Title of Change:	Revision of Case Outline 506AX.
Effective date:	24 Aug 2020
Contact information:	Contact your local ON Semiconductor Sales Office or IgnatiusPillay.FelixAmbrose@onsemi.com
Type of notification:	This Product Bulletin is for notification purposes only. ON Semiconductor will proceed with implementation of this change upon publication of this Product Bulletin.
Change Category:	New revision of Case Outline 506AX
Change Sub-Category(s):	Datasheet/Product Doc change

MECHANICAL CASE OUTLINE
 PACKAGE DIMENSIONS

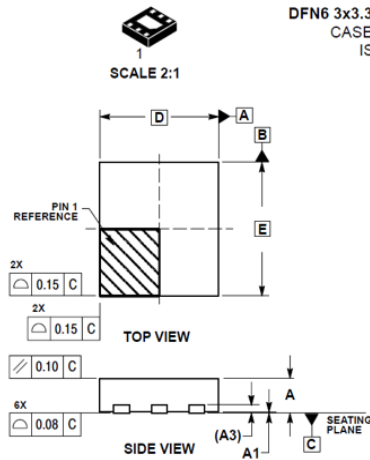
To change the A dimension, package thickness from 0.80mm to 0.90mm to 0.80mm to 1.00mm for case 506AX.
 No change to solder footprint is required. There is no material or manufacturing change; this is a document update only to align to standards and manufacturing capability

CHANGE A DIMENSION MAX LIMIT TO 1.00MM INLINE WITH JEDEC SPEC

MECHANICAL CASE OUTLINE
PACKAGE DIMENSIONS

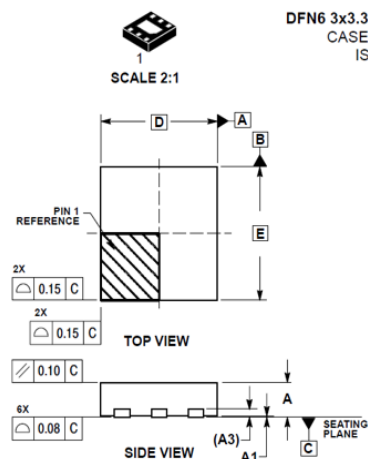
A 寸法の変更にともない、506AX ケースのパッケージの厚さが 0.80mm から 0.90mm を、0.80mm から 1.00mm に変更。はんだフットプリントへの変更はありません。材料や製造上の変更はありません。規格や製造能力への適合を目的とした、ドキュメント上の更新のみです。
